Request For Information

RFI-069

Subject: BP3 Steel Reconciliation Conf
Project: Steamboat - BV BP Promenade and Goldwalk
Address: 2305 Mount Werner Circle
Steamboat Springs CO 80487 USA
Phone:
To: Jim Gray
Zimkor, LLC
From: Saunders Construction, LLC

3 3/4" = 1'-0" NEW STEEL ON EXISTING PIT WALL

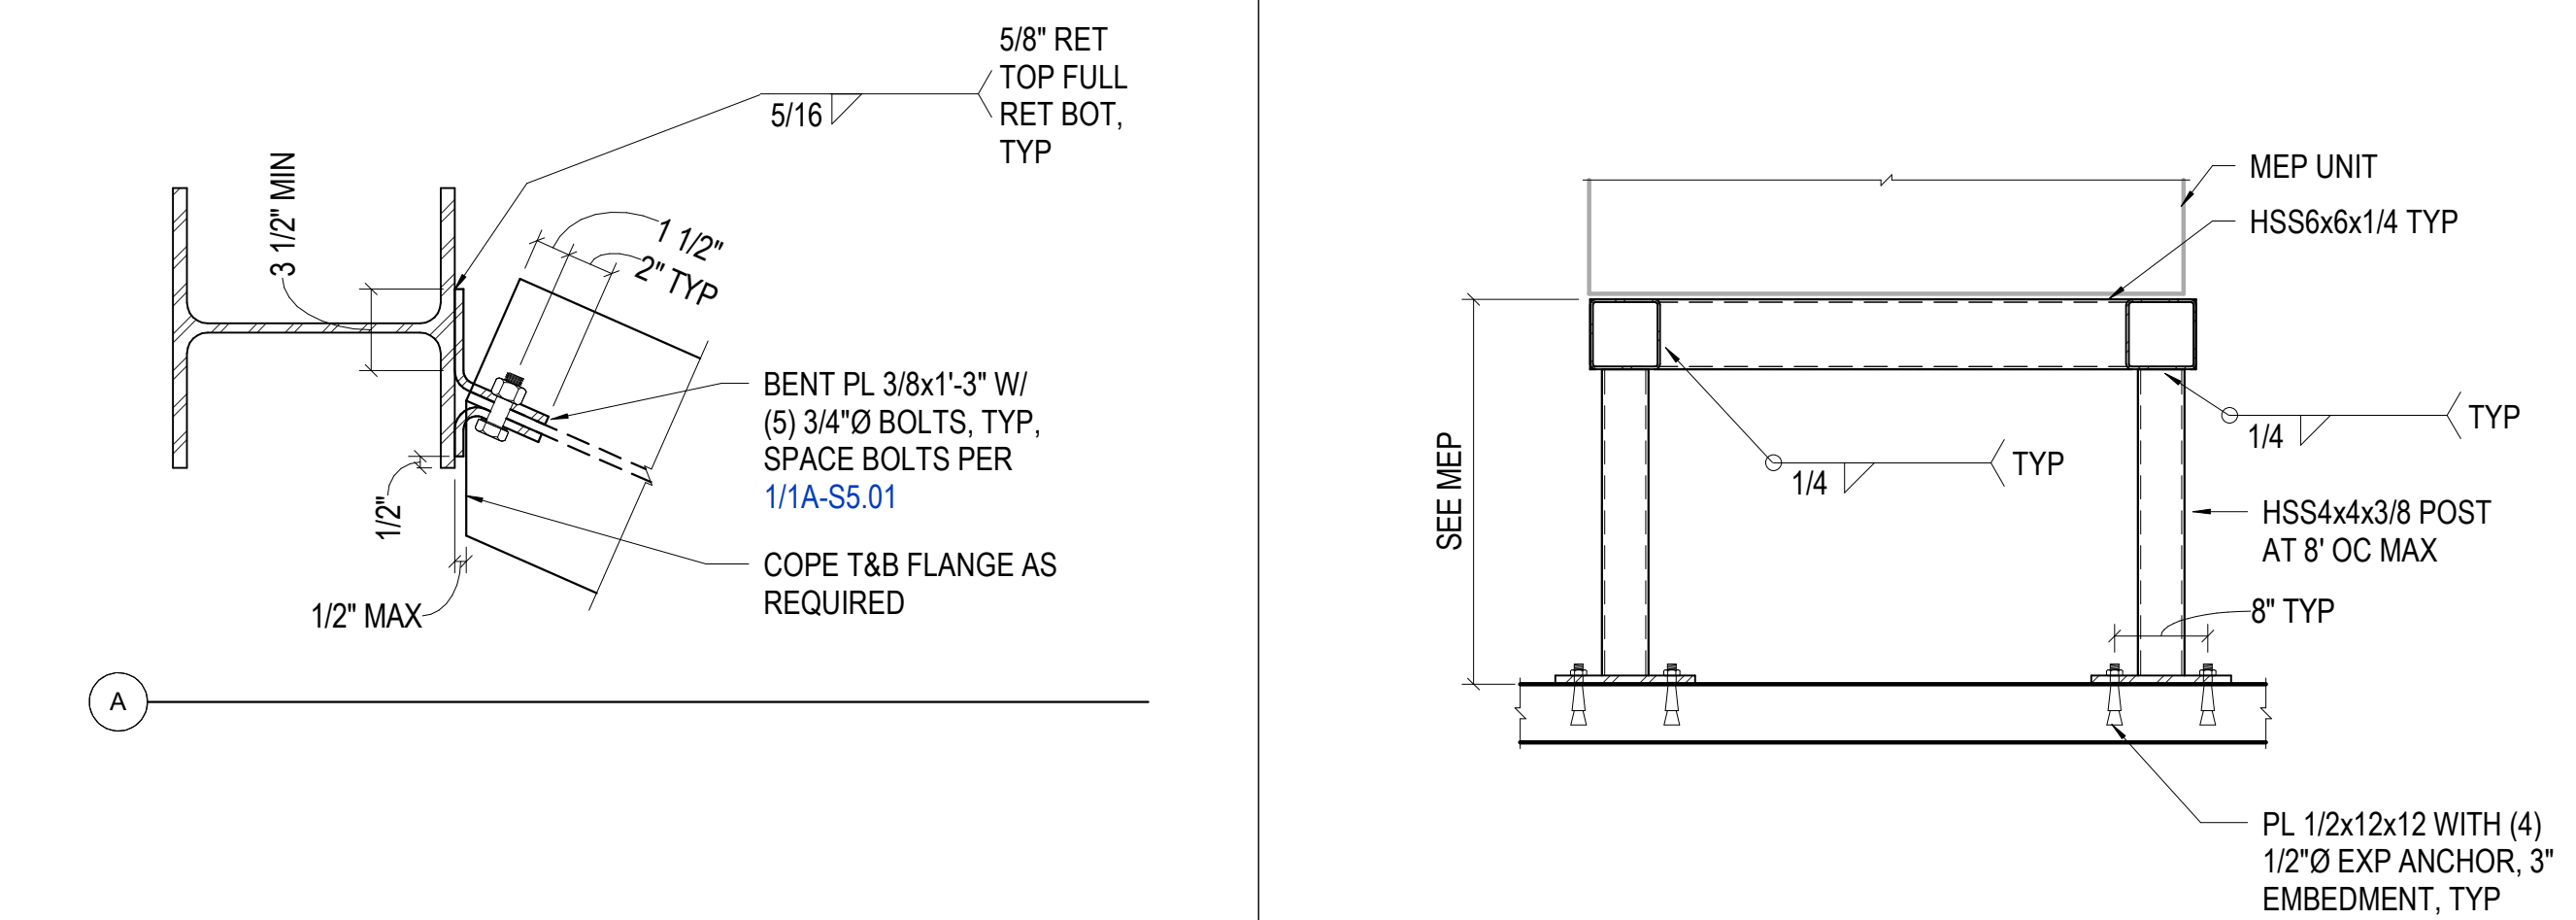
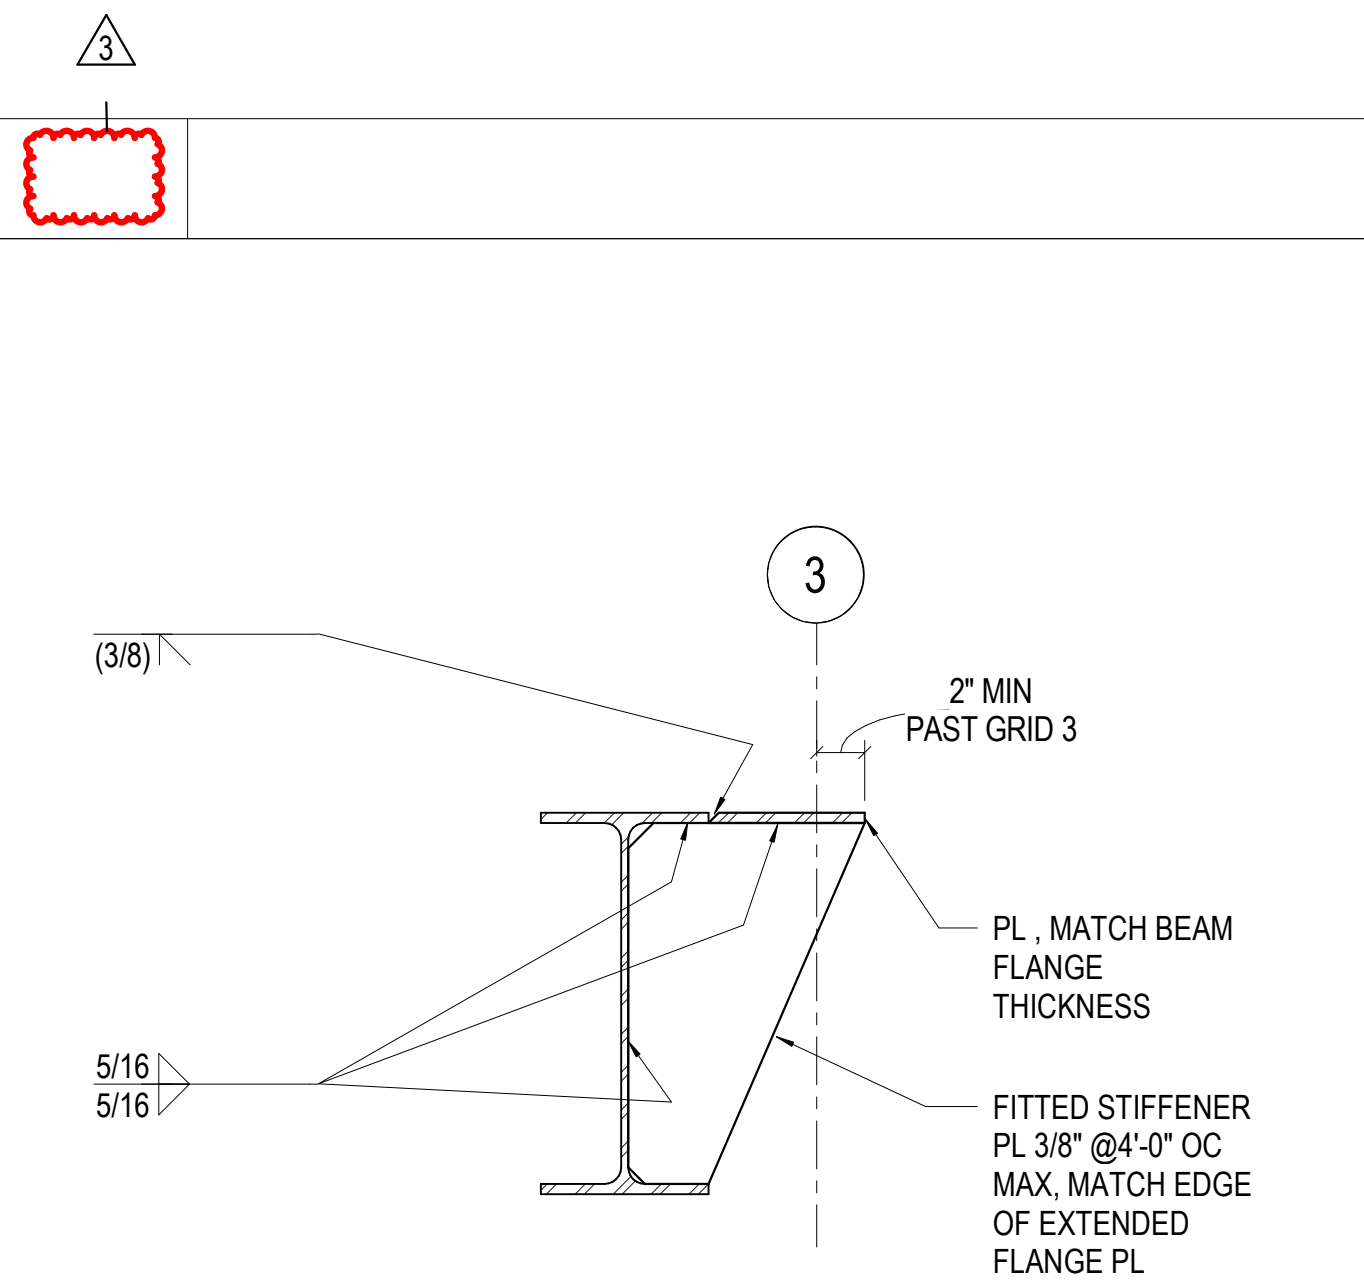
Following release of Promenade Bulletins 5 & 7 further structural steel and foundation changes were needed to be made in order to reduce schedule impact associated with design changes. Please confirm the attached print with updated sheets 1A-S1.00, S1.01, S4.01, S5.02, S5.03 and S5.30 is the final change document to be followed.

CONFIRMED.
KK/MM 8/19/21

SEE ATTACHED DRAWINGS WITH CORREC TITLE BLOCK
JAPPLE GENSLER 8/20/21
